## Production: **Airmate-USB TELCO MODULE**

Improvement of gain range for incoming Phone calls in Airmate-USB Telco channel

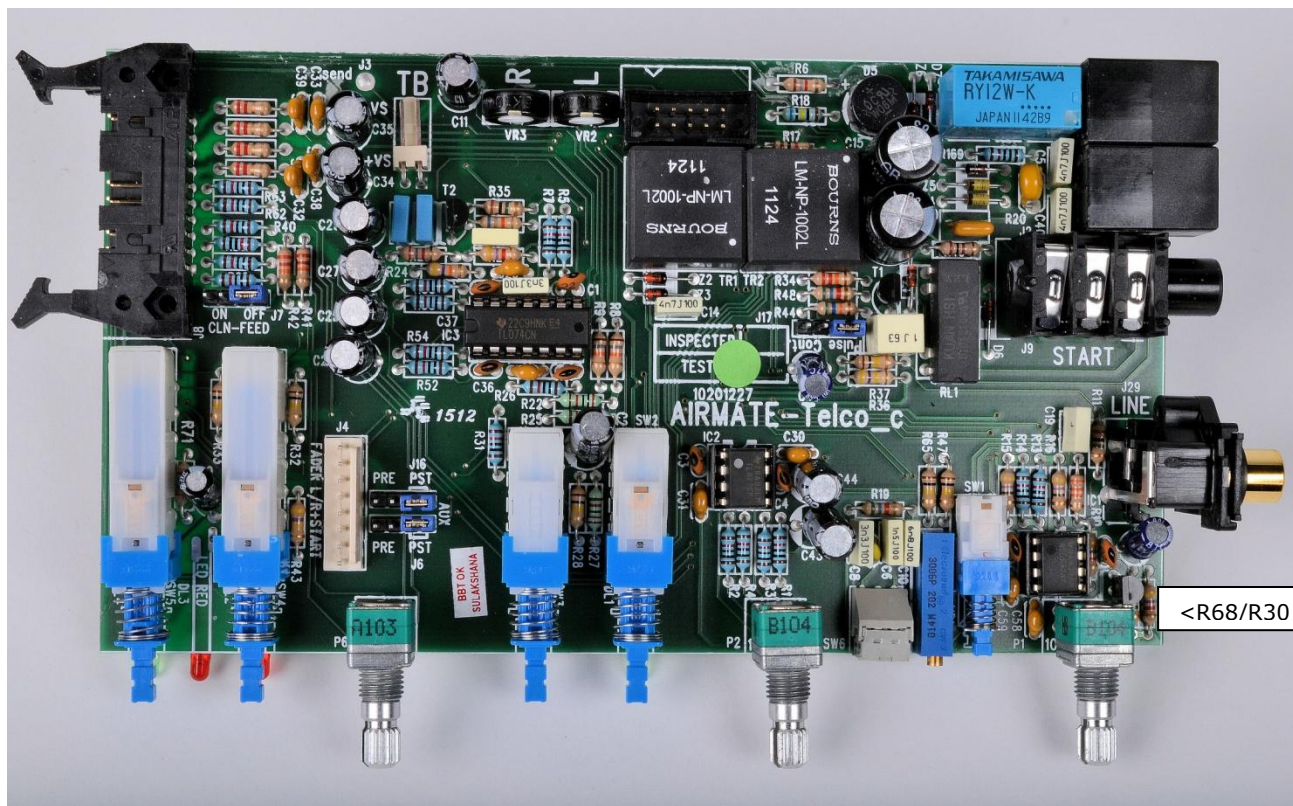
Improvement of gain range of Telco send potentiometer.

1. Replace R68 (1M) by 10K
2. Replace R30 (4K7) by 10K
